CITY OF ALBUQUERQUE

Re: Balloon Fiesta Park Sid Cutter's Pilots' Building

Grading and Drainage Plan

Engineer's Stamp Date 7-2-14 (B17D001F)

TITLE:				
	OVERALL G	RADING PLA	M	
Design Review Committee	City Engineer Approval	MO.	/ DAY / YR.	MO. / DAY / YR.
resign review communes	Oity Engineer Approval	Update		06 JUNE 2014
		dn L		
		Design		
		ast De		
				,
City Project No.		Zone Map No.	Sheet:	Of
XXXX.XX		B-17-Z

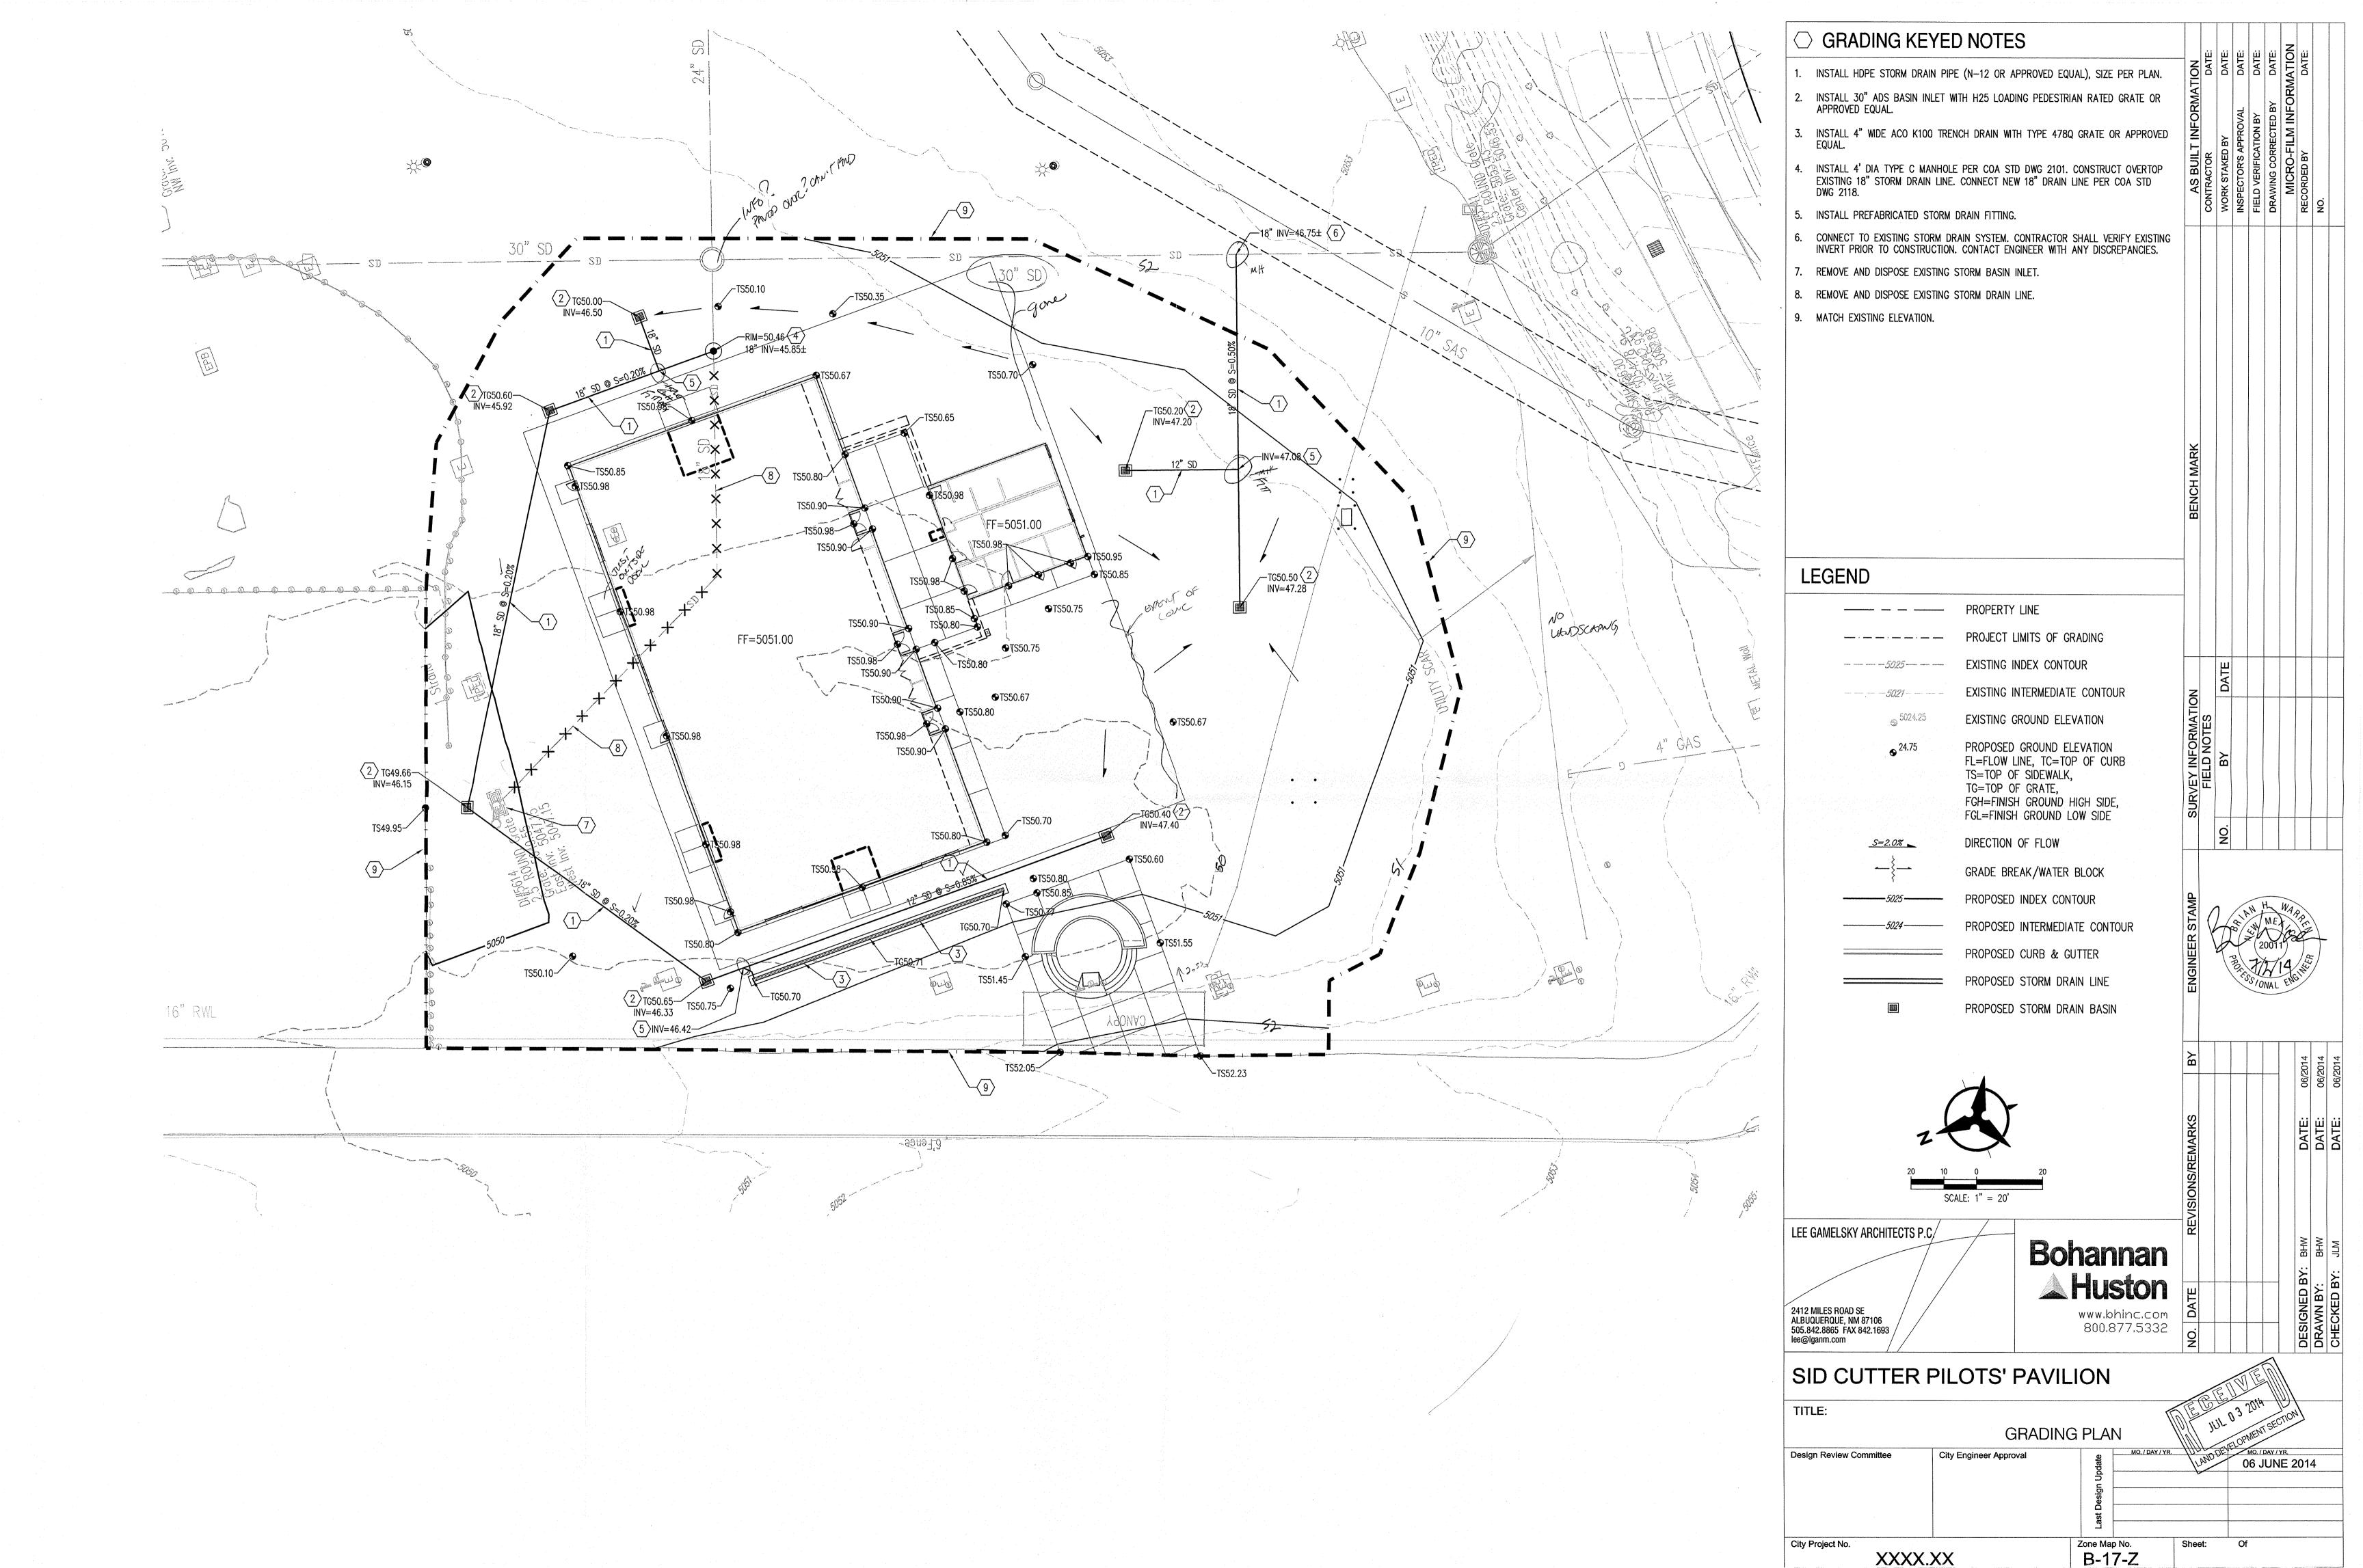
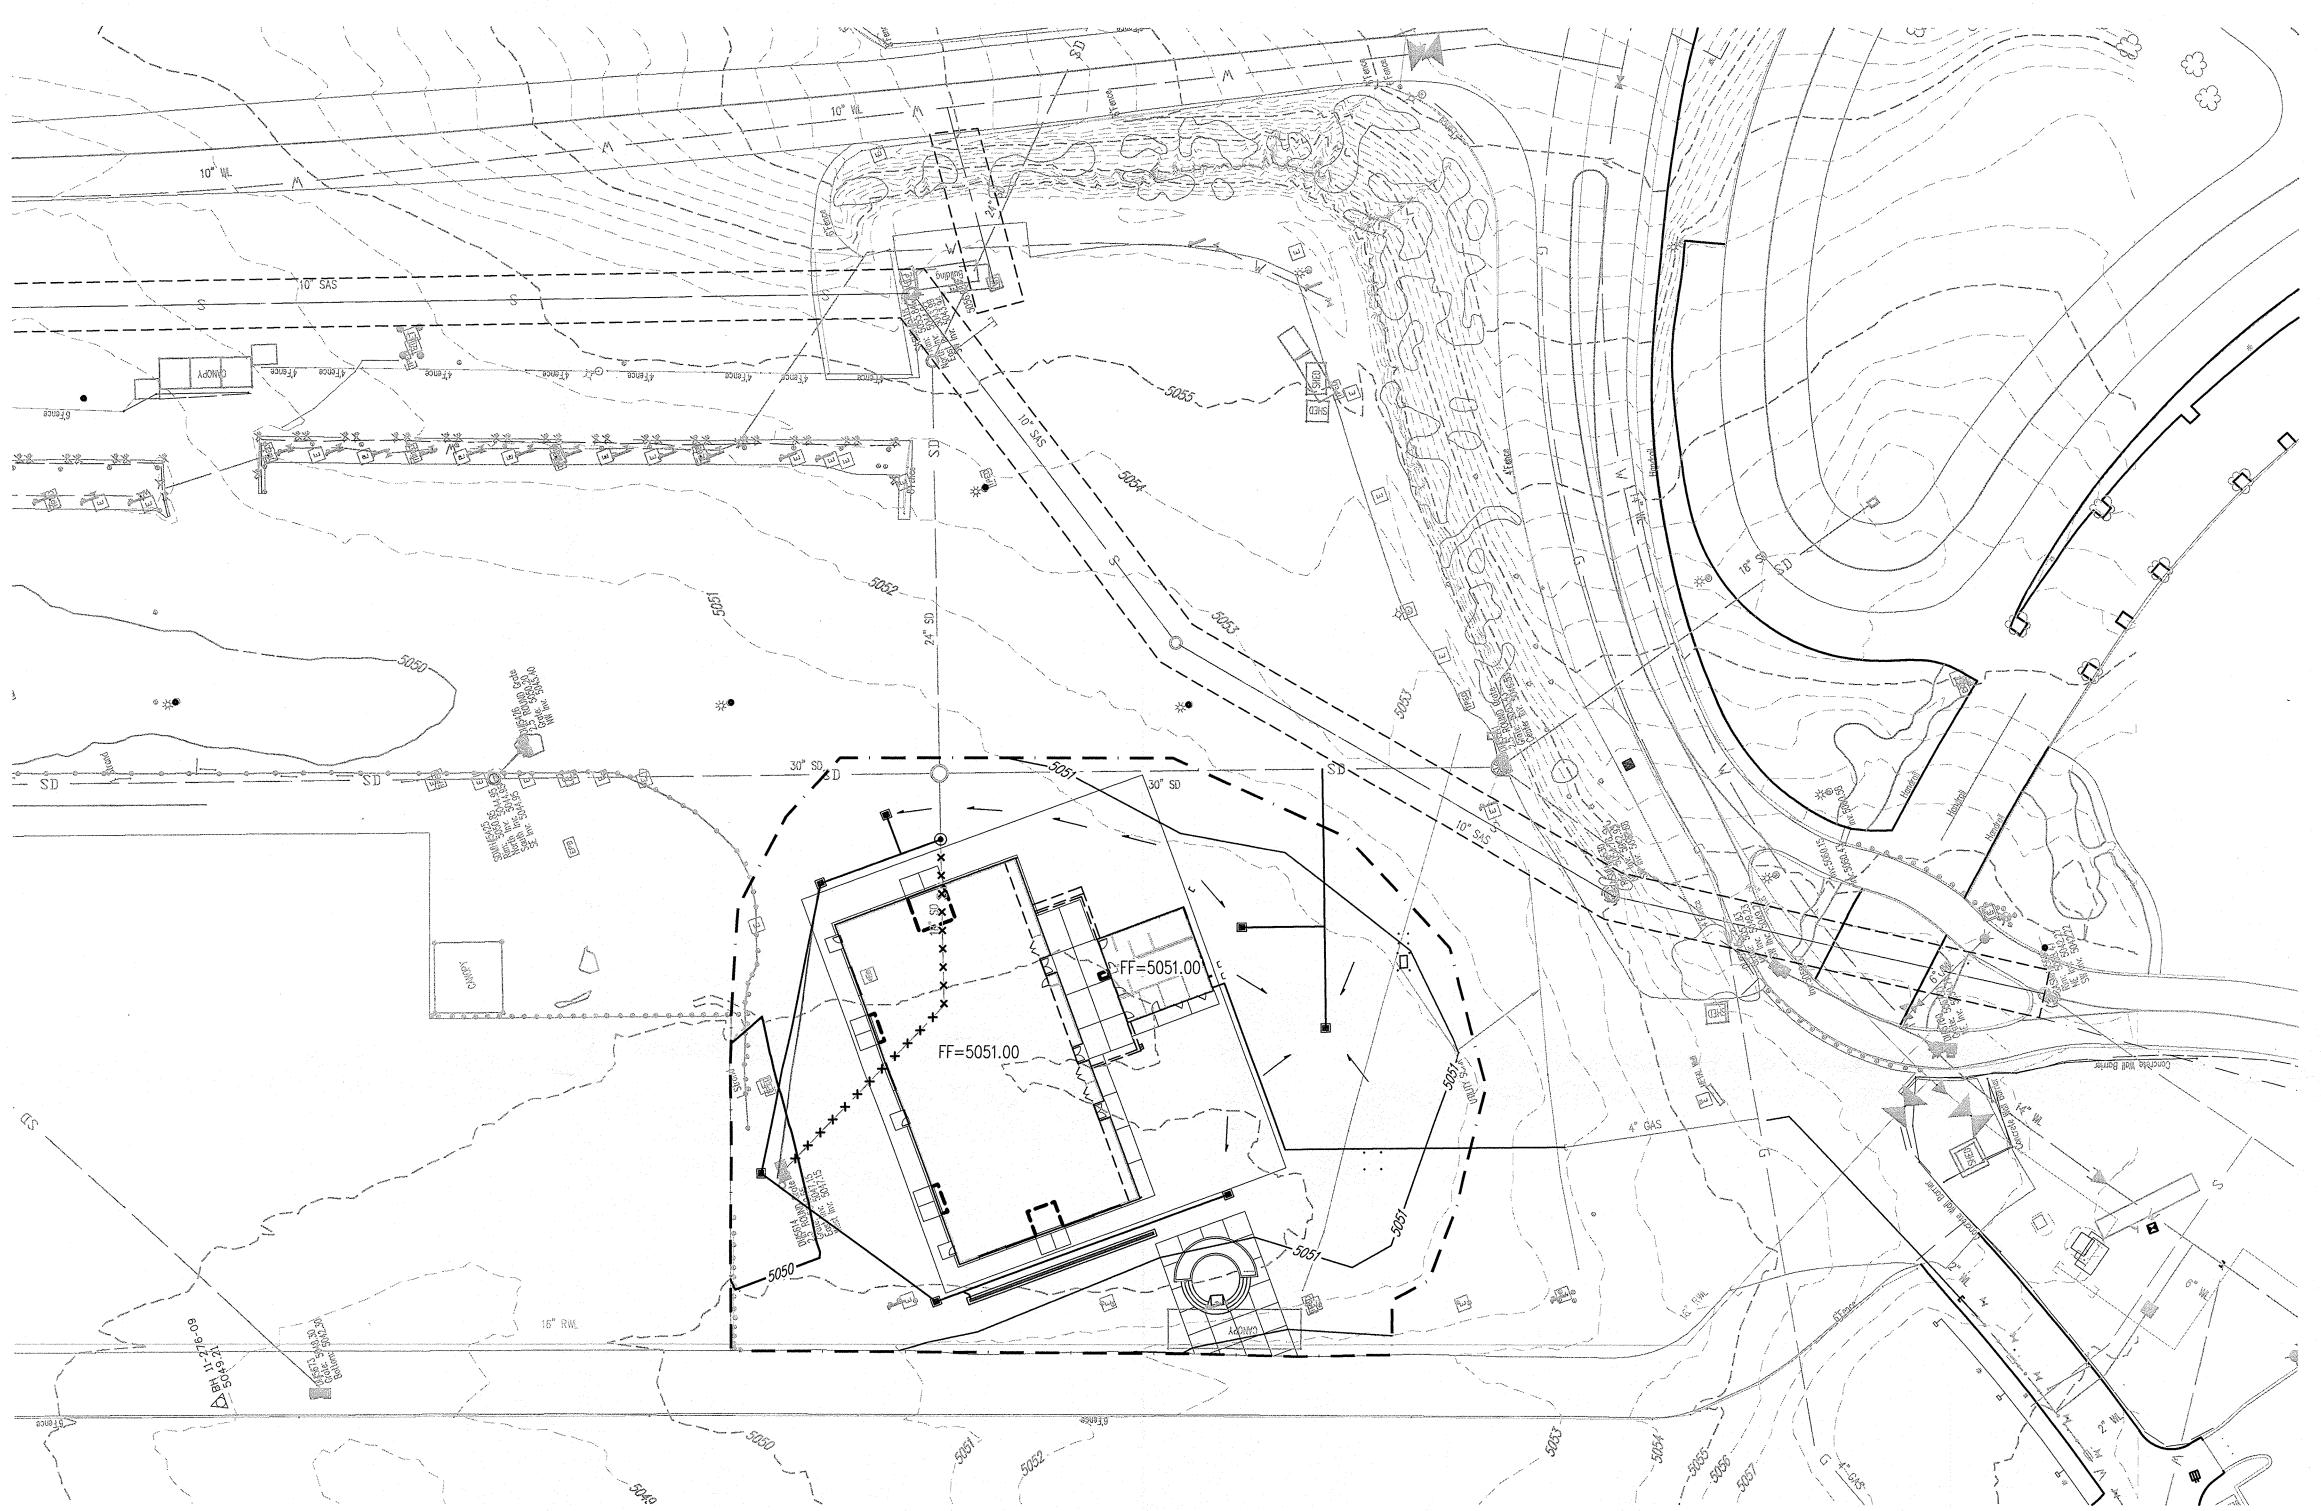
- The building is different especially on the east side from what was approved for Site Development Plan for Building Permit. What percentage of the building has changed? Has the site plan gone in for an Administrative Amendment? You mentioned a second phase being done for this project. Provide a site plan showing the second phase.

- 2. Show a vicinity map and a FIRM map with the site location. Include a benchmark on the drawing.
- 3. Provide calculations showing the storm drain is adequately sized. Show on-site and off-site basins with flows. Discuss what flows are coming onto the site.

- 4. Include manholes at all 90 degree junctions where you do not have them now. For all manholes and inlets, provide inverts in and out. Show the rim and invert elevations of the existing manhole at the intersection of the existing 30 inch and 24 inch storm drains.

- 5. Is parking provided? Where are vehicles entering the site? Please show both.
- 6. For Note 5, specify the type of fitting such as tee and size.

- 9 See updated but not submitted G+D 1/31/4 Billion Fasta Porks Plot Blog B17 DOOIF 1. BENCHMARIC, VICENITY MAP, FIRM MAP LEGAC DECAR 2. X 18 82 IN PLEBIC EXSE? > PROVIDE NOW OUT PHUVANZ 1 3. OXIST PHUNG COT (asph) 4. What are grades along wast. Ad Is all of road shown Rd imposting darty 1. Sundending grades - Show resulting Whit spots To contains. Exist roud not shown as east 5. Area of grading shown on conceptional met Profit see Show onfuel I that concert?

This included two new inlets. 6. Show cales showing SD adequately MH at junction. Pronde TAVIN FORT 7. Fust flush rgd SPRP 5/9/14-No 8 Uhy putting new inlet next to out inlet 1 pv + one very close. Not sensible

9. Note 5- specifif fitting 528 MME -darff

Electron pubmettal Do admin amend Callana historia Dinama canto Alanian and to have yes in Assuming all this is proofer -no expensets or core pipe red -inst dom & HDPE 16. Show me eler of west MH at 30'1424" Basn's pofsik flower in the besnit complet of correspond plan 17. APPLD GID VORY DIFF FROM MOXT DUE 18. 819E PLANGERBY DIFF FROM THIS SUB - 8HOW PARO
